# VALUE ENGINEERING REPORT

## Cable Barrier Installation

P.I. Nos. 0009619, 0009818, 0009819, 0009820, 0009821, and  
0009822

December 21, 2010

CABLE BARRIER DETAIL  
WITH CONCRETE STRIP

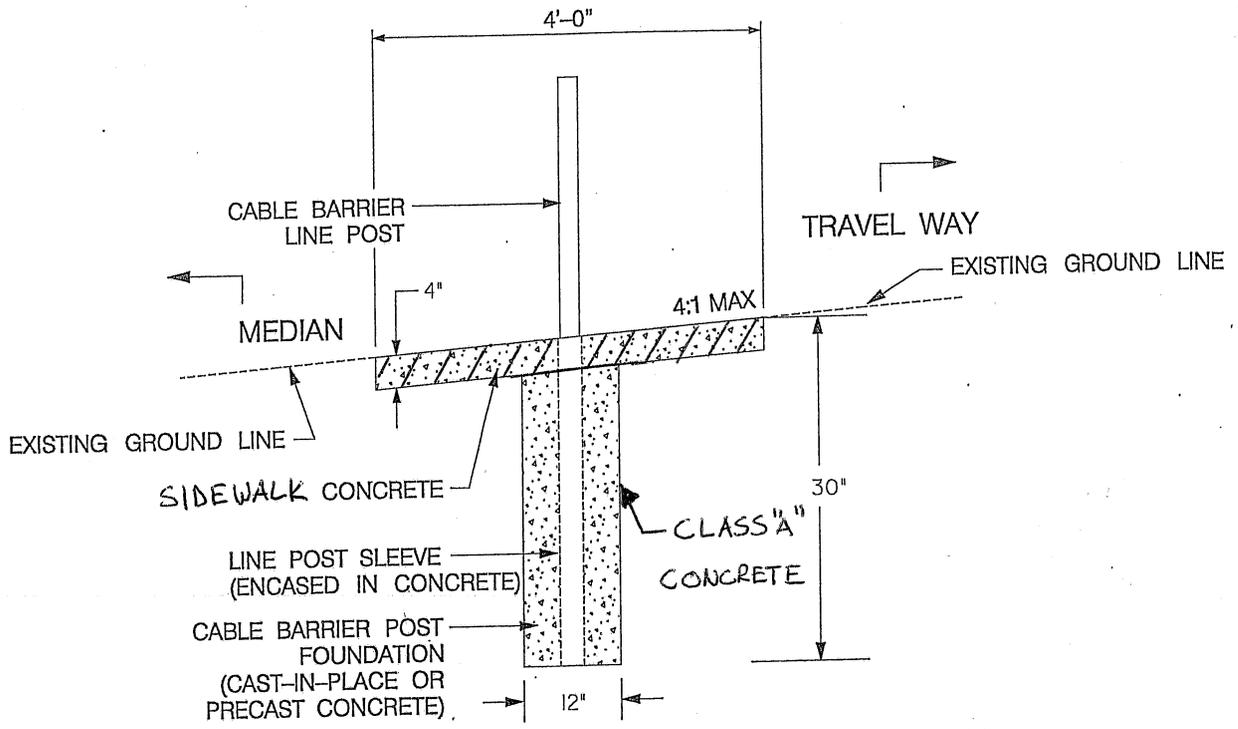
The original concept proposes to install Class A concrete for the mow strip and post foundations.

The revised concept proposes to install sidewalk concrete for the mow strip and Class A concrete for the post foundations.

The primary function of the mow strip is to prevent the growth of vegetation around the cable barrier and prevent damage from mowing operations. This function can be addressed by the implementation of using sidewalk concrete and will result in significant cost savings. This idea will result in a two step construction process where the post foundations will be placed first and the mow strip second. Costs shown reflect concrete material costs savings only.

CABLE BARRIER DETAIL  
WITH CONCRETE STRIP

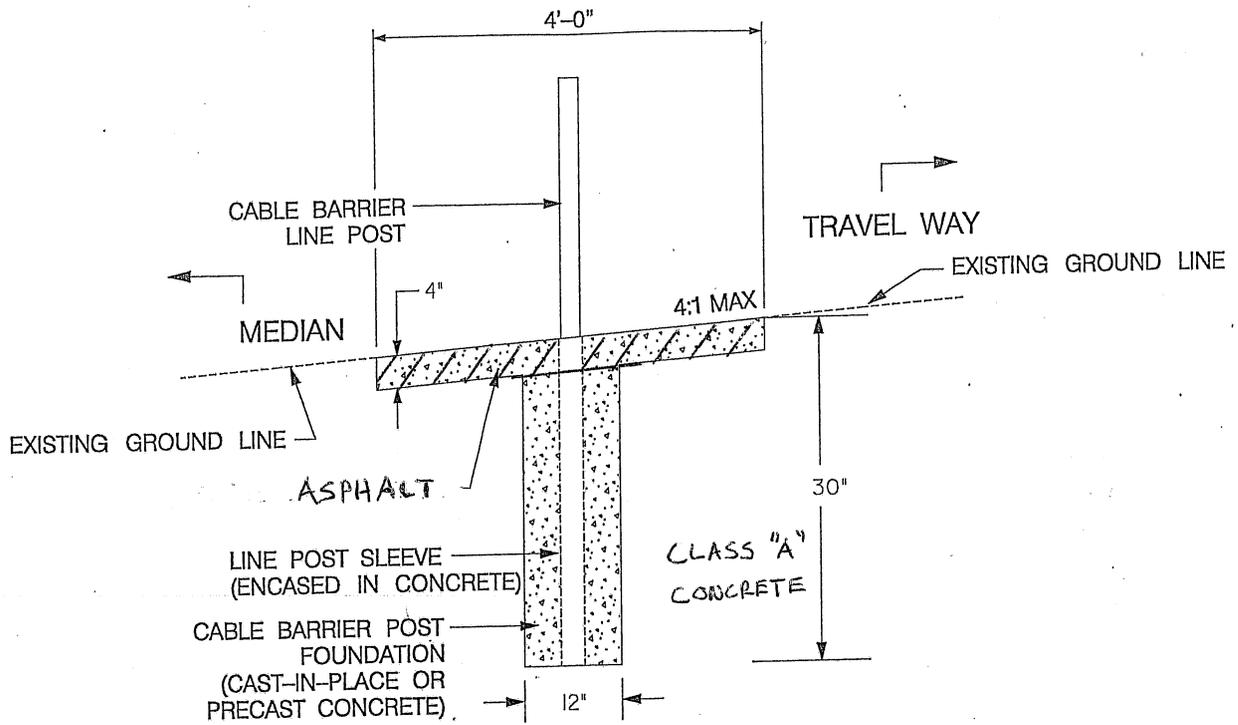
The original concept proposes to install Class "A" concrete for the mowing strip and the post foundations.

The revised concept proposes to implement asphalt for the mowing strip and Class "A" concrete for the post foundations.

The primary function of the mowing strip is to prevent the growth of vegetation around the cable barrier and prevent damage from mowing operations. This function can be addressed by the implementation of asphalt and will results in significant cost savings.

### CABLE BARRIER DETAIL WITH CONCRETE STRIP

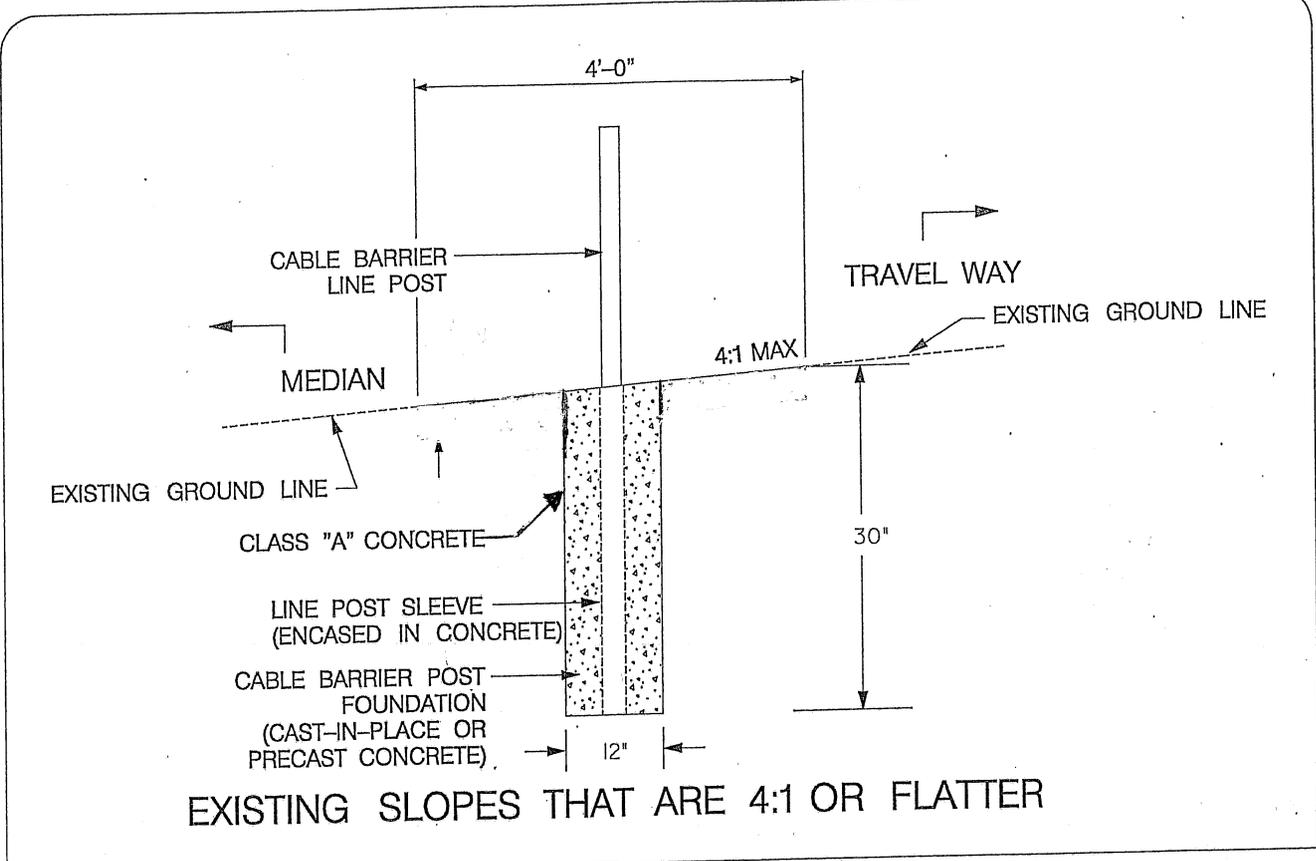
The original concept proposes to install Class “A” concrete for the mowing strip and the post foundations.

The revised concept proposes to eliminate the mowing strip and install Class “A” concrete for the post foundations.

The primary function of the mowing strip is to prevent the growth of vegetation around the cable barrier and prevent damage from mowing operations. This function can be addressed by the implementation of additional maintenance with small equipment and will result in significant cost savings.

CABLE BARRIER DETAIL  
WITH CONCRETE STRIP

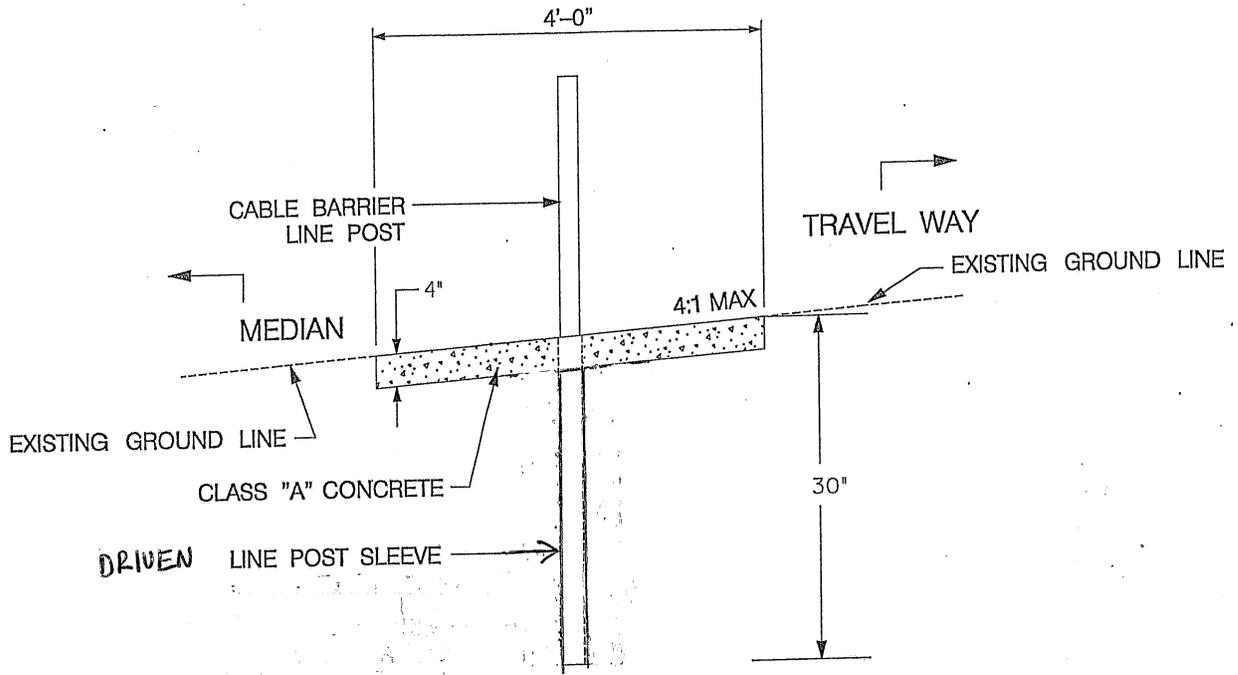
The original concept proposes to install posts in concrete foundations.

The revised concept proposes to install posts in driven sleeves without concrete foundations.

The primary function of the concrete foundations is to stabilize the posts. This function can be accomplished by installing driven sleeves with a significant cost savings.

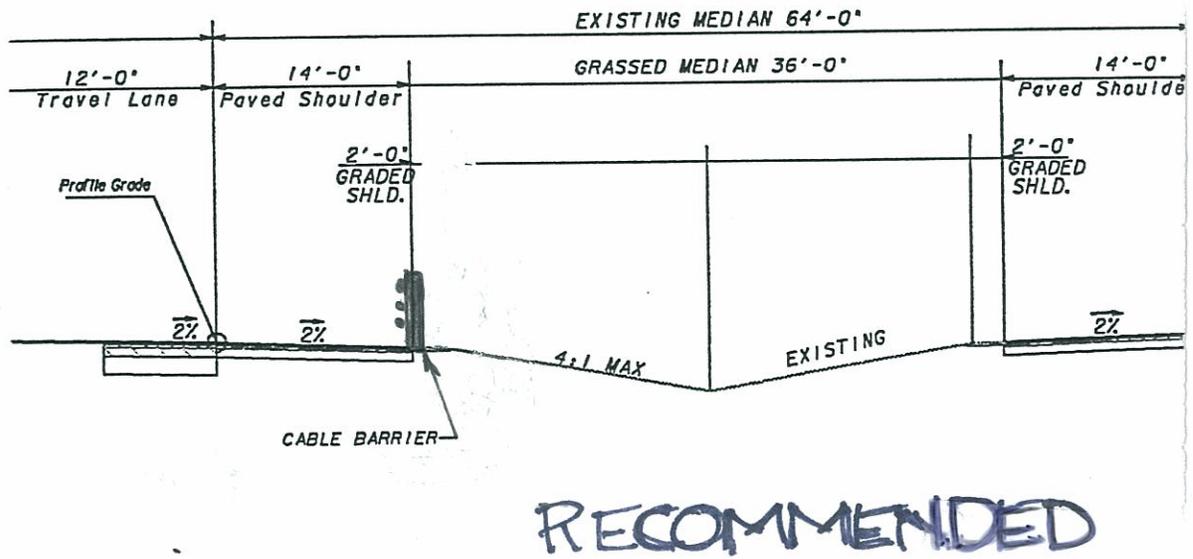
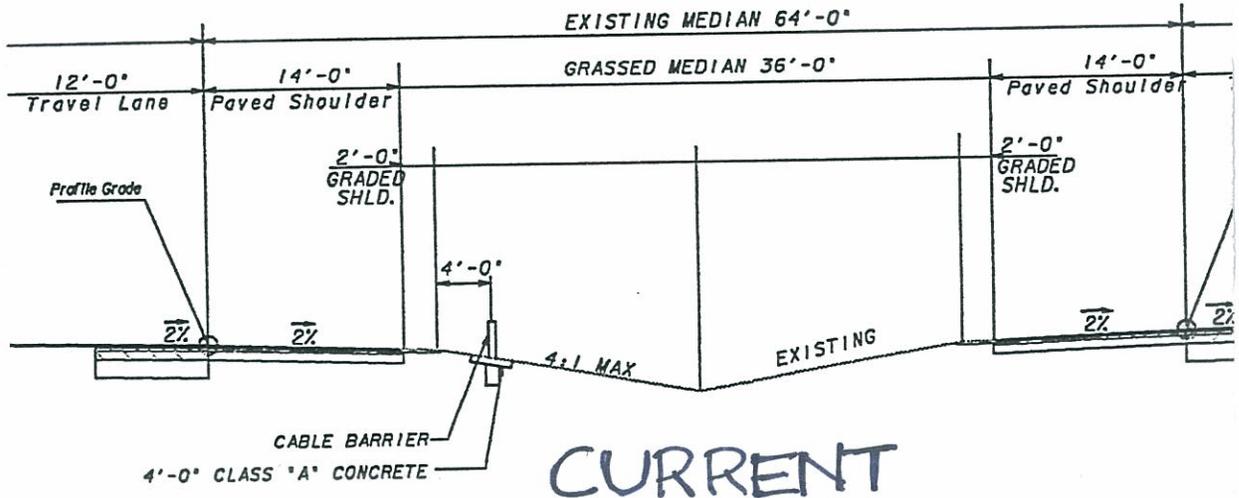
Shifting the cable barrier to the edge of the paved shoulder, where there is at least a 12 foot shoulder, will eliminate the need for the concrete mowing strip by utilizing the paved shoulder as maintenance-free surfacing. Relocating the barrier with a minimum 12 foot area will still allow ample room for the 9 – 10 feet of deflection as well as a full 12 feet for disabled vehicles to pull off the mainline.

Based on discussions with the GDOT district representatives, the lack of a mowing strip did not reveal a significant maintenance problem. Even if some posts are occasionally damaged and need to be replaced, this is a minor cost.

Additionally, there will be some nominal savings by reducing the erosion control measures where the mowing strip is eliminated.

Figure 6.1 Guidelines for median barriers on high-speed, fully controlled-access roadways

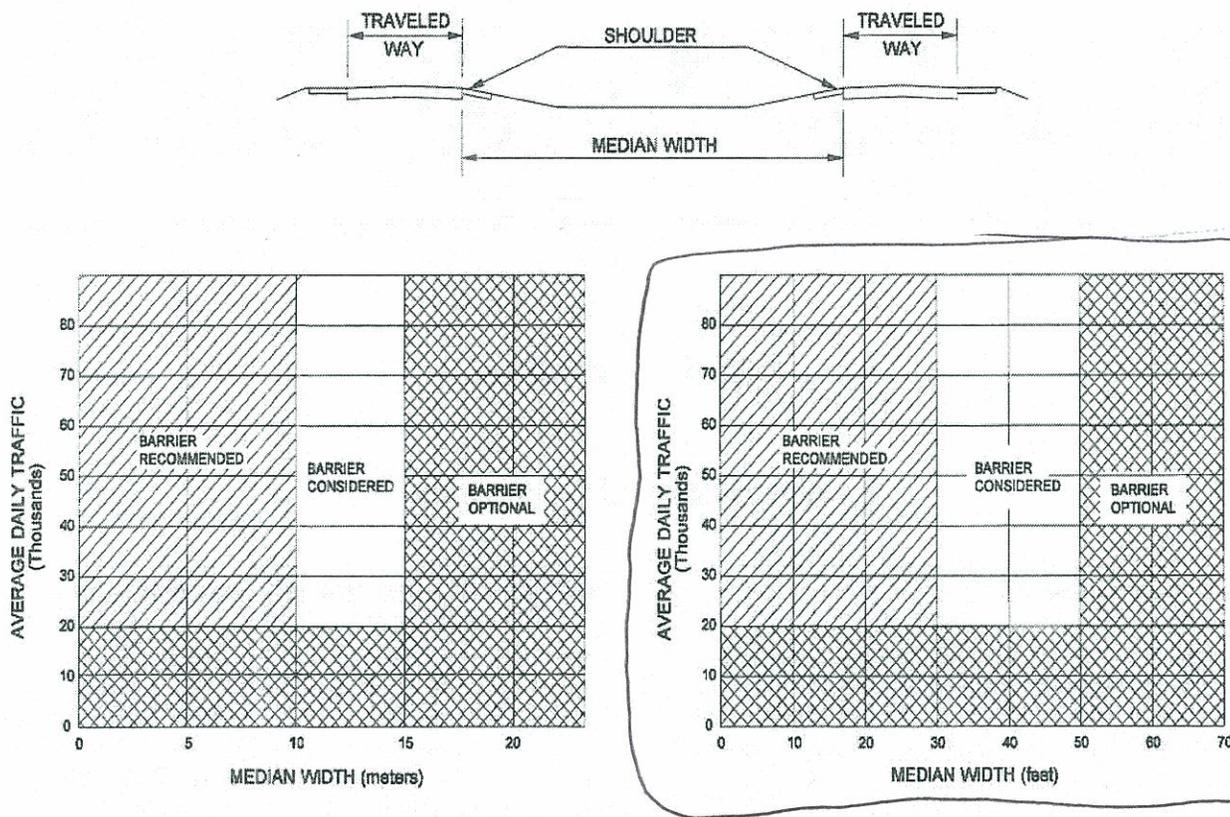
Utilize data presented in Chapter 6 of the AASHTO Roadside Design Guide (2006), specifically Figure 1 and accompanying text found on page 6-2, which recommends installation of median barrier on “high-speed, fully controlled-access roadways for locations where the median is 30 feet in width or less and the average daily traffic (ADT) is greater than 20,000 vehicles per day” (vpd). This section goes on to recommend that median barrier installation be considered when the median width is between 30 and 50 feet and ADT is greater than 20,000. Installation is noted as optional where median widths are less than 50 feet and ADT is less than 20,000 vpd. In addition, this section notes that installation of median barrier is “not normally considered” for locations with median widths greater than 50 feet unless there are special circumstances, such as a history of significant cross-median crashes.

According to the data provided, the method utilized by GDOT used a minimum median width of 34 feet, but set no maximum width; therefore, a large number of roadway segments with median widths greater than the AASHTO breakpoint width of 50 feet were included in the data selection. According to the typical sections provided in the proposed plans, approximately 75 percent of the roadways included in the six proposed projects have median widths of 64 feet or greater, and would be considered optional installations unless warranted by high crash data. As noted in the calculations discussed on the following pages, some of these optional installation locations do warrant a median barrier based on the high crash rates. In addition, there is a question of whether or not those roadway segments with median widths less than 34 feet are being addressed.
